Access Compliance Report

Public Rights-of-Way

(Curb Ramps)

Intersection ID: 45634	Main Street: LAKE_RD	Cross Street: MOLLY_ELIZABETH_LN	Location: SE
ADA ID: 630ECD9B5D12	Ramp Type: Perp	Initial Pass/Fail: Fail	Overall Compliance: No
Severity Score: 30			
Codes/Mitigation Info/Possible Solution		Field Measurements/Component Compliance

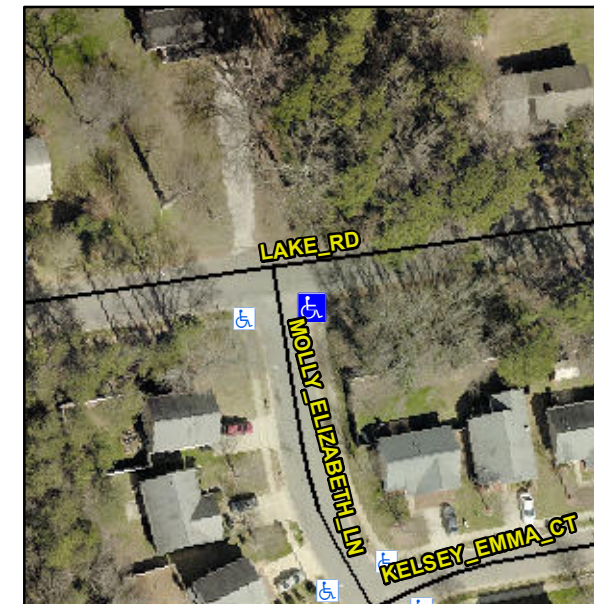
Not Found, R304.5.1, R304.2.2

Compliance	Description	Data	Compliance	Description	Data
N/A	Ramp Length (in)	48.0	No	Ramp Slope (%)	8.5
No	Ramp Width (in)	34.5	Yes	Ramp XSlope (%)	0.4
N/A	Flare Type LT	N/A	N/A	Flare Type RT	N/A
N/A	Flare Slope LT (%)	N/A	N/A	Flare Slope RT (%)	N/A
N/A	Flare Traversable LT?	N/A	N/A	Flare Traversable RT?	N/A
N/A	Landing Length (in)	N/A	N/A	DWS Provided?	N/A
N/A	Landing Width (in)	N/A	N/A	DWS Contrast?	N/A
N/A	Landing Slope (%)	N/A	N/A	DWS Length (in)	N/A
N/A	Landing X Slope (%)	N/A	N/A	DWS Full Width?	N/A
N/A	Landing Curb? (Y/N)	N/A	N/A	DWS Offset (in)	N/A
N/A	Shared Landing?	N/A			
N/A	Gutter Ponding?	N/A	N/A	Gutter Slope (%)	N/A
N/A	Gutter Lip Ht (in)	0.75	N/A	Gutter X Slope (%)	N/A
N/A	Painted X Walk1?	No	N/A	Painted X Walk2?	N/A
	X Walk 1 Direction	To W		X Walk 2 Direction	N/A
N/A	X Walk 1 Width (in)	N/A	N/A	X Walk 2 Width (in)	N/A
	X Walk 1 Slope (%)	1.0		X Walk 2 Slope (%)	N/A
	X Walk 1 X Slope (%)	0.8		X Walk 2 X Slope (%)	N/A

Remove & Replace Entire Ramp.
